pd-trigger — Design Document

ai-ee v1 pipeline

Board review (P8 adversarial) - pd-trigger

5 Schematic

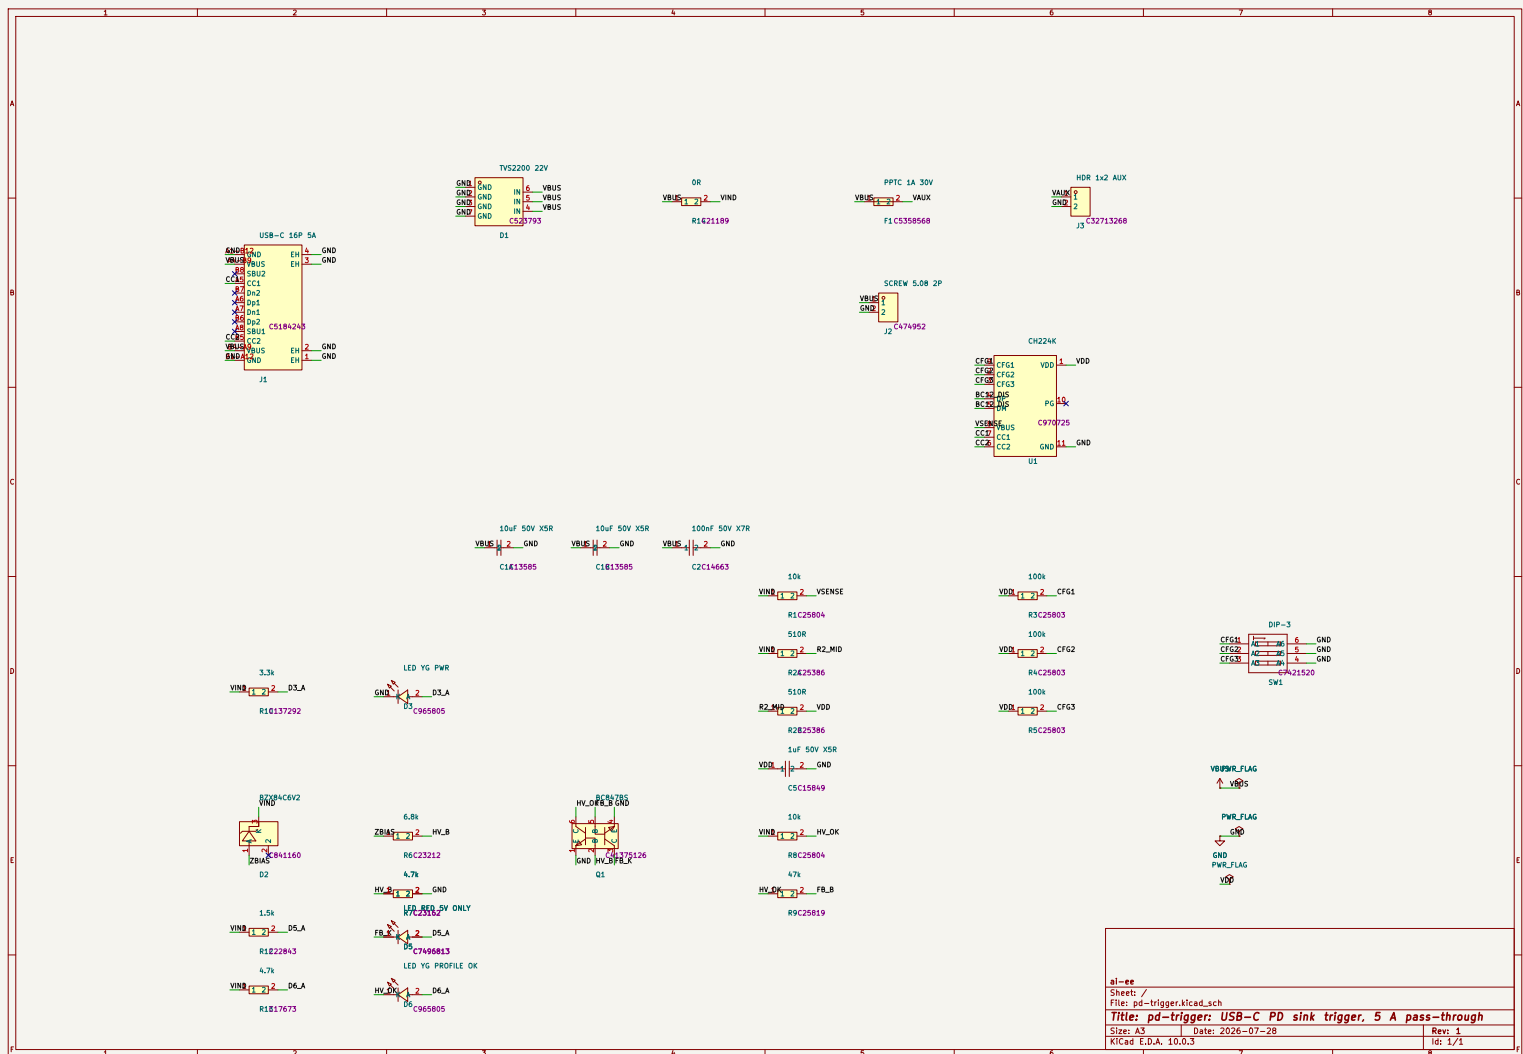
W1 dp-dm-short-at-chip: architecture’s PD-only short (`/BC12.DIS`) ACCEPTED by the reviewer as hardware-SAFER than the datasheet’s connector wiring (removes a 21V-onto-3.8V-abs-max fault path). Cost: no QC/BC legacy support - the board is “PD sources only”; goes on B.SilkS + order docs. W2 vdd-worst-corner: true worst case 0.979mA at 4.4V low-line all-straps- closed vs unpublished CH224K IDD - bounded by WCH’s own reference circuit; V1 bring-up step: measure VDD at the 5V profile; contingency = both 510R -> smaller (documented floor 600R total). Bring-up addenda: buzz out Q1 E/B/C once (clone PDF JS-gated; Nexperia- standard pinning verified as the compatibility claim).

reports/render_final/top.png

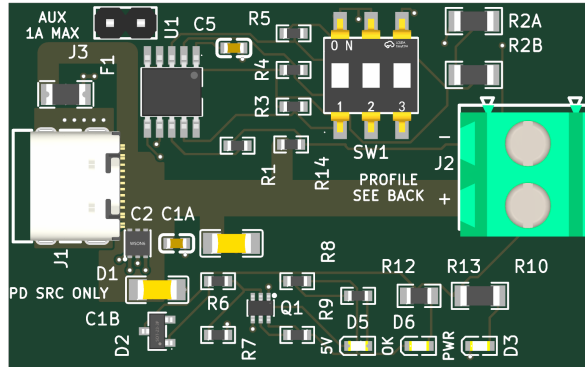
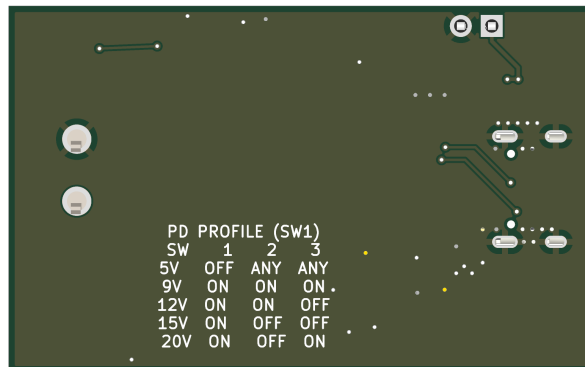
E1 - 5 A return chokes at J1's GND contact pads (error, checker-blind by design D7)

The 4 GND cable contacts land on two merged SMD pads (F.Cu only): A1-B12 at (17.63,39.31) and B1-A12 at (17.63,45.71), nominally 2.5 A each at the 5 A rating. Their ONLY copper into the B.Cu return pour:

- A1-B12 (top): a 0.2 mm wide, 2.7 mm long F.Cu chain (3 segments) into shell pad 1's THT barrel, plus one 0.6/0.3 via whose annulus grazes the pad corner by ~0.05 mm (etch-tolerance-level). 0.2 mm at 2 oz = 0.80 A capacity at 10 C rise (pipeline model); at 2.5 A the same model gives ~133 C rise (short-neck heatsinking will moderate this, but it is a >3x overcurrent on the model's own terms). ~13.6 squares = 3.3 mohm.
- B1-A12 (bottom): a 0.2 mm x 1.3 mm trace into ONE 0.6/0.3 via. The board's own via budget (constraints via_amps 0.5) says 2.5 A needs 5 vias; there is 1. Shell pad 4 sits 0.32 mm away but is NOT connected on F.Cu - its copper does not help.

Architecture D7/power_tree structural requirement ">= 10 vias at J1's GND pads" (the stated substitute for keeping GND out of power[] so check_current stays quiet): not delivered. DRC cannot see it (0.2 mm is netclass-legal), check_current cannot see it (GND undeclared), check_return_path no-ops (no high_speed key). Failure mode: sustained 5 A at any profile heats the two necks far past the 10 C design intent; long-term trace/joint fatigue, intermittent ground, and full return current cascading onto the surviving 0.2 mm chain. Fix is cheap at P9: an F.Cu GND spandrel bonding each contact pad to its shell pad (the VBUS pour top edge is at y 39.7 - the strip above it, and the strip x < 17.2 plus the region south of y 46, are free) plus 4-5 vias per side.

E2 - Safety/waiver silk markings absent (error, promised artifact) Board-wide gr.text count is ZERO; B.SilkS carries nothing at all (both B.SilkS references in the file are the stackup layer table). Missing, each one a written promise:

- AUX 1A MAX + V+/GND at J3 (P0 answer 4 "silk-marked", V10). F1 makes overload safe-by-hardware, but polarity of the 2-pin aux header is unmarked.
- PD SOURCES ONLY (ERC waiver W1's standing condition: "goes on B.SilkS + order docs"). The waiver's silk half is currently unfulfilled.
- J2 screw-terminal polarity. Trunk lands on J2 pad 1 = the LOWER screw (board-bottom side); nothing anywhere tells the bench user which screw is V+. Reverse-wiring a load on a 100 W output is the single easiest field mistake this board can cause.

E3 - User-interface silk absent (error, promised artifact)

- The five-row profile table on B.SilkS - D3 calls silk "the user interface" and specifies the table verbatim; the bottom is a clean pour with room. Without it the ON/OFF-to-voltage map exists only off-board; a user WILL set 9 V expecting 12 V by trial and error. (Fail-safe floor: any wrong guess >= the 5 V fallback, and OFF-fail = 5 V - the mistake is bounded but real.)

- LED legends PWR / 5V ONLY / PROFILE OK (D4/V10): the render shows refdes D3/D5/D6 only. The entire P0-answer-6 "visible fallback indication" scheme is mute without the words - a lit red LED labeled "D5" indicates nothing.

W1 - J1 mouth recessed ~0.4-0.5 mm behind the board edge (warning, flagged at P6) Courtyard/silk front edge $x = 10.18$ vs board edge $x = 9.8$. USB-C receptacles are normally flush-to-overhanging; a recessed mouth lets thick/molded plug overmolds butt the board edge and hold the plug fractionally short of latch - intermittent CC, no PD, "works with some cables". On a bare bench board with arbitrary cables this is a real annoyance risk. Fix: nudge J1 -x 0.5-1.0 mm at P9 (pour edge follows; nothing else in that corridor), or accept and note in order docs.

W2 - Outline 48 x 30 mm exceeds the architecture's hard ceiling (warning, drift) Edge.Cuts = (9.8,27.51)-(57.8,57.51) = 48 x 30 mm. D9: nominal 45 x 25, "hard ceiling 48 x 28 mm"; 30 mm violates D9's own ceiling by 2 mm even though it equals P0 answer 5's literal +20 % (40x25 -> 48x30, +44 % area vs the brief's target). No digest discloses the growth past D9. Consequence is cost/footprint only, but it must be disclosed to the user at the checkpoint rather than discovered.

A1 - J2 GND pad ties to the return pour through 4 thermal spokes (advisory) J2 pad 2 (THT, 2.4 mm pad / 1.6 mm drill) connects via 4 x 0.5 mm diagonal spokes = 2.0 mm total at 2 oz -> model 8 C rise at 5 A. Legal and functional, but these are the most-loaded copper necks on the whole return after E1, at a hand-soldered joint. Recommend a solid-connect override (or a short fat GND strap) at P9; zero cost. (Verified all 4 spokes present; the VBUS pad 1 island below it is barrel-tied, normal.)

A2 - F1's VBUS feed branch is 18.3 mm long (advisory, V8 letter-violation) V8/D8 wanted all five VBUS taps hugging the run with 2-3 mm stubs. D1, C1A, C1B, C2, R14 comply; F1's feed runs 8.4 + 6.5 + 3.4 mm at 1.75 mm width to the top-left corner. Width-compliant (V8's actual purpose), carries ≤ 1 A in service; only cost is ~30 mm² of extra always-live 20 V copper. No action needed; recorded as drift.

A3 - Floating 0.65 mm² GND sliver at (20.0, 28.5) (advisory, cleanup) plane_repair's own dead-island fact (0 anchors), between J3/SW1 clearances. Cosmetic / minor DFM nit; remove at P9 cleanup or accept.

A4 - /VAUX at PPTC max-non-trip current (advisory) /VAUX routes at 0.3 mm (required 0.25 at the declared 1.0 A -> 7 C). F1's worst sustained NON-trip current is ~1.8 A -> model 27 C rise on those runs until/unless the PPTC trips. Bounded, no damage threshold approached (70-80 C copper on a 20 V node); acceptable. Recorded so nobody "fixes" it blind later.

```
# P8 digest (pd-trigger)
verify PASS 8/8 first try. Fable reviewer: 4 err + 2 warn. Copper errors
REAL: 5A RETURN choked at J1 GND pads (0.2mm necks/0.80A, 1 via) - rebuilt
w/ priority-1 F.Cu GND lobes (connect.pads solid) + 15 new 0.6/0.3 vias ->
5.68A/4.70A per pad, 16 vias (D7 >=10 met). Removed 2 stitch vias 0.121mm
from THT drills - LIVE-PROVEN KiCad DRC blind spot (via-drill vs same-net
pad-drill never checked, finding 34). Silk errors: 17 texts added; agent
CORRECTED the orchestrator's B-table spec (raw CFG bits would be inverted
vs ON=GND switch reality - printed switch positions). Warns: mouth recess
-> order docs; outline 48x30 deviation recorded; C1B channels waived w/
numbers. Re-gates: drc_routed 0/0, verify 8/8. H4 AUTO-approved.
```
